F.I. – Work Brake Valve Replacement

Certain Mack LR model trucks with a dual drive, when the work brake is turned off, there is a 5 second window where the driver can shift gears with no service brake applied.

Follow the instructions outlined in the document to relocate the Quick Release (QR) valve and add a double check valve.

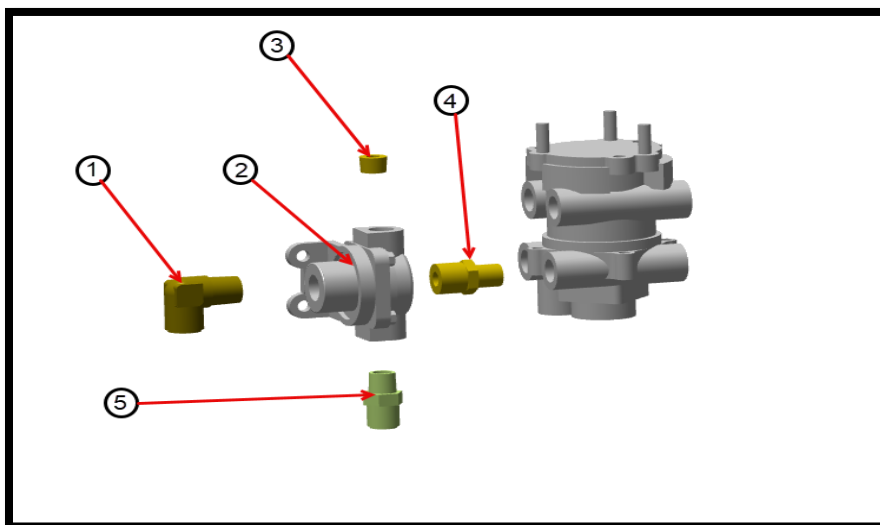
1. Secure the vehicle for service.
2. Locate the QR Valve on the right-side brake valve.
3. Remove the QR and discard fittings that are no longer required.

Item	Description	Disposition
1	½ NPT (90-Deg Fitting)	Discard
2	QR Valve	Keep for relocation
3	3/8 NPT (Plug)	Keep
4	3/8-1/2 NPT (Nipple)	Discard
5	3/8 NPT (Stright Fitting)	Discard

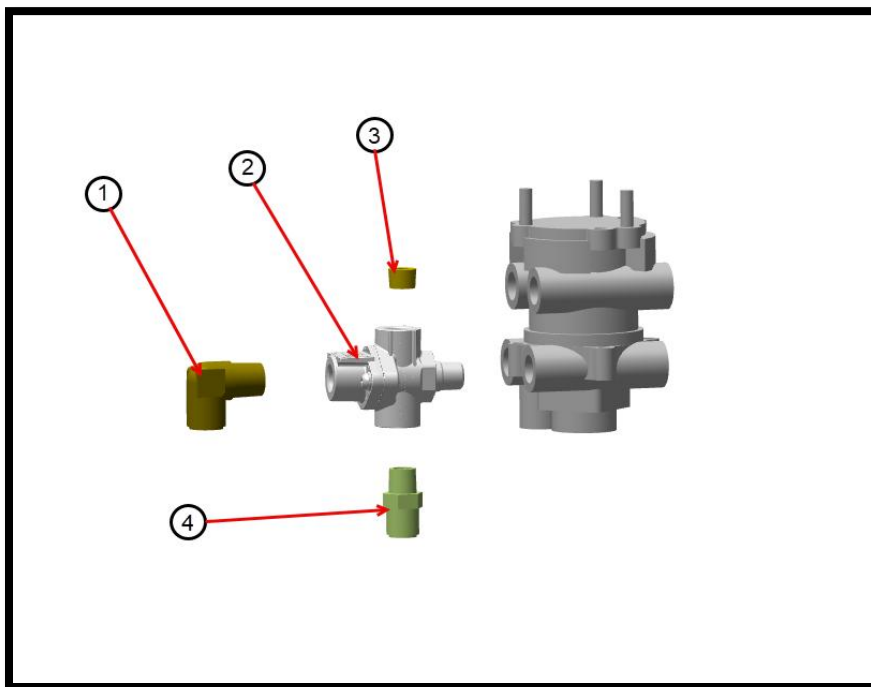
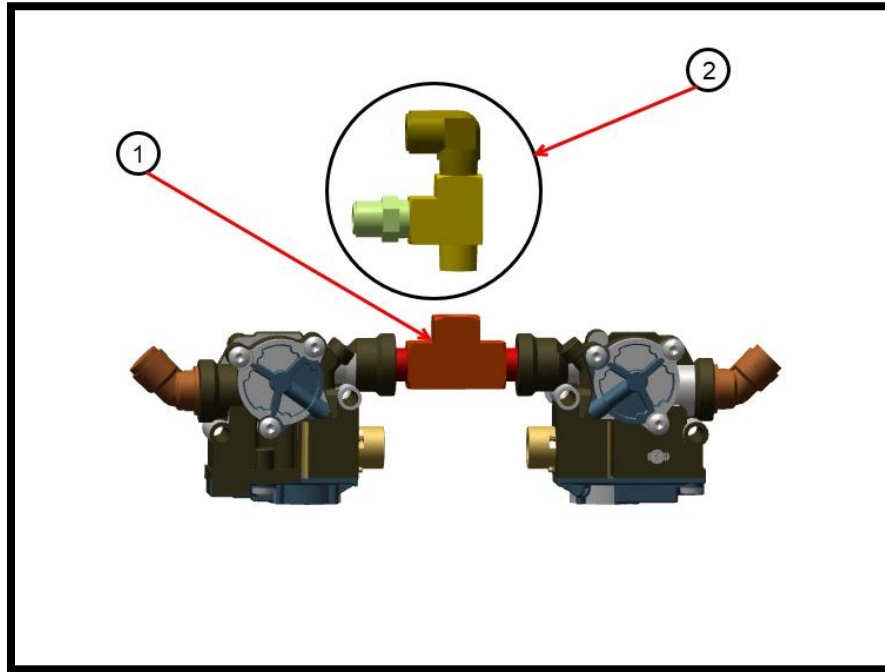
4. Install the check valve **24737096** in the brake valve where the QR valve was removed.

Item	Part Number	Item description	Designation
1	26009198	3/8 NPT (90-Deg Fitting)	Install in port #12 of check valve
2	24737096	Check Valve	Install in port #22 of brake valve
3	Reuse from QR Valve	3/8 NPT (Plug)	Install in port #21 of check valve
4	Reuse from QR Valve	3/8 NPT (Stright Fitting)	Install in port #22 of check valve

38 ± 1.9 Nm (28 ± 1.4 lb_r-ft)

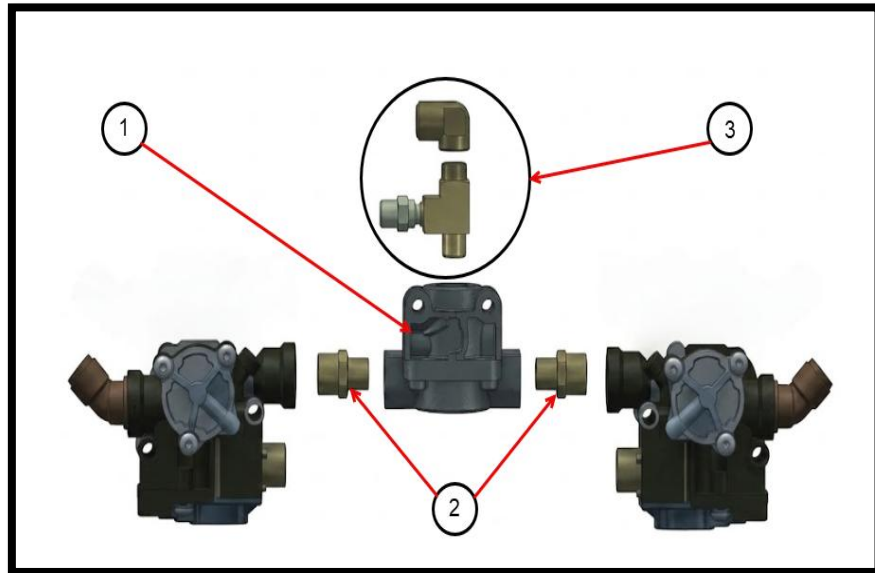
5. Locate and remove the steering axle modulator valve assembly.
6. Remove the tee fitting and install the QR valve previously removed from the brake valve.

Item	Item description	Disposition
1	½ NPT (Tee Fitting)	Discard
2	Tee and fitting assembly	Keep

Item	Part Number	Item description	Designation
1	Reuse	QR Valve	Install between the modulator valves
2	3180120	3/8 NPT-1/2 NPT (Nipple)	Install in between modulator and QR valve
3	Reuse	Tee and fitting assembly	Install in the supply port of QR valve

Torque Spec.	
3/8 NPT Fittings	38 ± 1.9 Nm (28 ± 1.4 lb _r ·ft)
1/2 NPT Fittings	68 ± 4.0 Nm (50 ± 3.0 lb _r ·ft)
